MEMORANDUM DATE: April 4, 2022

RE: **428 North J Street**

TITLE: HRPB Project Number 22-00100146: Consideration of a Certificate of Appropriateness (COA) for the demolition of an existing structure and the construction of a ±1309 square foot single-family structure with a ±342 sf accessory structure on Lot 14, Block 114 at **428 North J Street**; PCN #38-43-44-21-15-114-0140. The subject property is located in the Single-Family/Two-Family Residential (SF-TF-14) zoning district and the Northeast Lucerne Local Historic District.

Exhibit A: Proposed New Construction – Street View

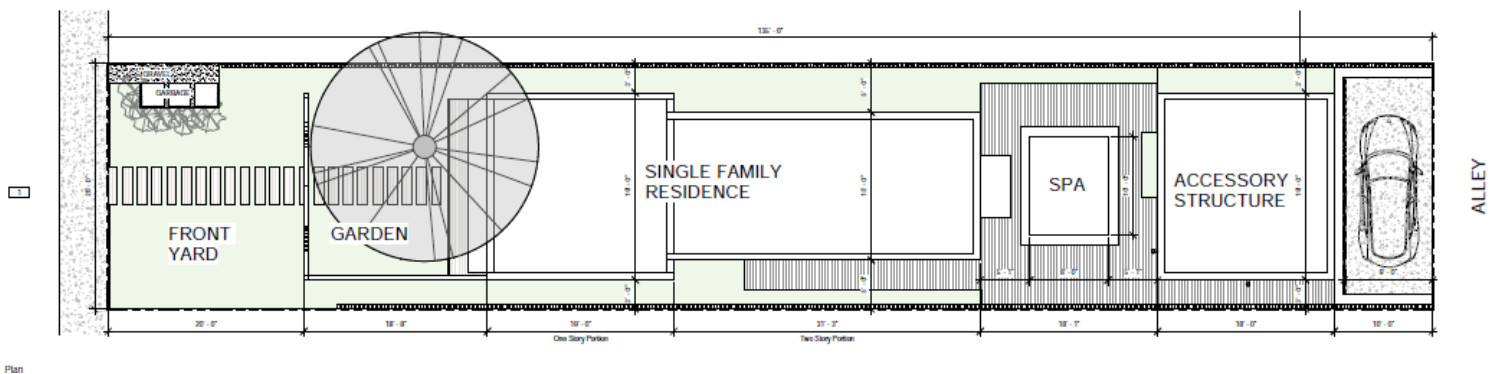
Staff Analysis: The proposed window openings on the front facades are typical for the shape of the building. The design's narrow façade, flat roof lines, and windows most closely resemble the massing of an international building, which utilize a simplistic structure with a noted lack of ornamentation.

Staff Analysis: The proposed design utilizes a unique aluminum slat façade to enclose the front garden. This façade merges the traditional design elements of the neighborhood with the more modern international design of the new construction. The entryways are connected to the public sidewalk via a paver walkway.

Staff Analysis: Although the design of the structure is modern in nature, it is compatible with other buildings in the historical district.
